G.O., No. 41, 22nd January 1906.

Sanctioning, with remarks, a maximum grant of Rs. 3,000 towards the cost of certain additions and improvements to the building occupied by the Sacred Heart School, Tellicherry.

Note by the Chief Engineer, dated 21st November 1905.

The estimate for additions and improvements to the Sacred Heart school at Tellicherry, in the Malabar district, is recommended for sanction with the following remarks:—

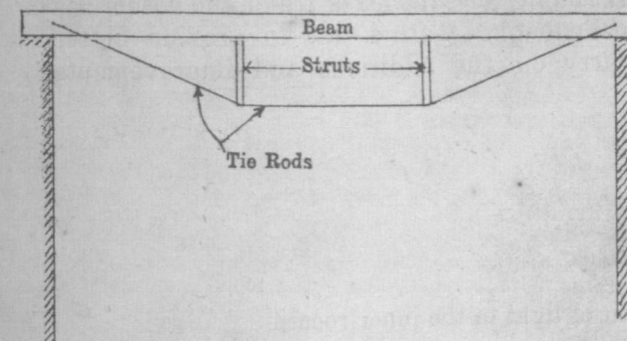
- (6) The trussing of the sagged beams should be carried out as per sketch in the margin. The wooden tie beam at the bottom (as shown on the plan submitted) should be omitted and the ends of the sloping tie rods should be as near the ends of the beams to be supported as possible.

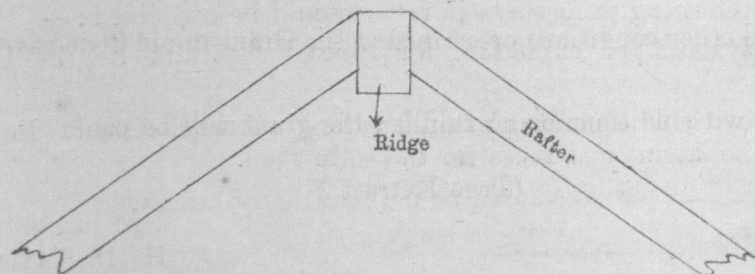
(12) The rafters should abut against the ridge and not rest on top of it, as per sketch—

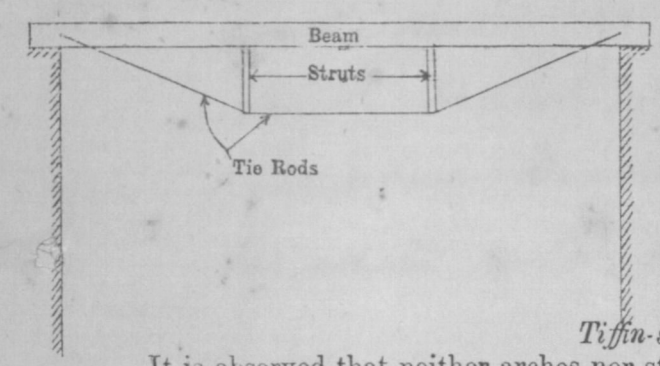
The trussing of the sagged beams should be carried out as per sketch in the margin. The wooden tie beam at the bottom (as shown on the plan submitted) should be omitted and the ends of the sloping tie rods should be as near the ends of the beams to be supported as possible.

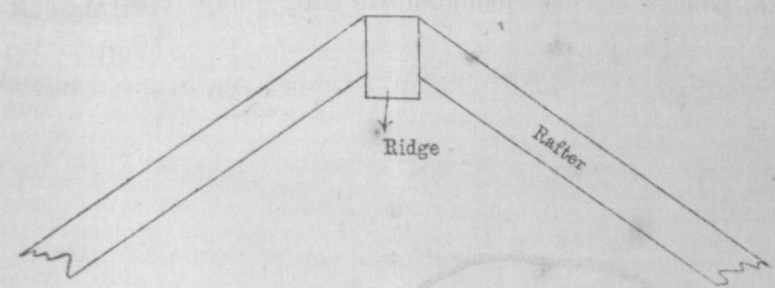
The rafters should abut against the ridge and not rest on top of it, as per sketch—

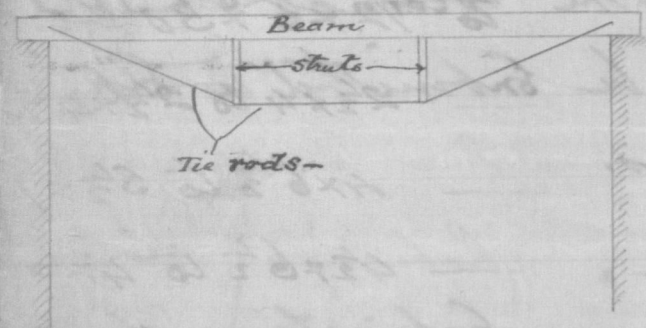
The tinning of the Sagger beams should be carried out as per sketch in the margin.

The wooden tie beam ~~shown~~ at the bottom (as shown on the plan submitted) should be

omitted and the ends of the supporting tie rods should be as near the ends of the beams to be supported as possible.

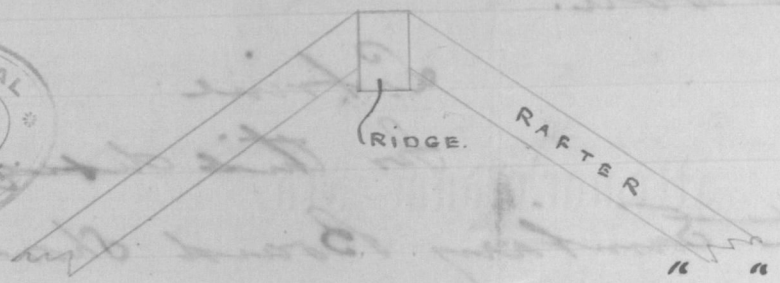
The rafters should abut against

the ridge and not ~~the~~ rest on top of it, as per sketch.
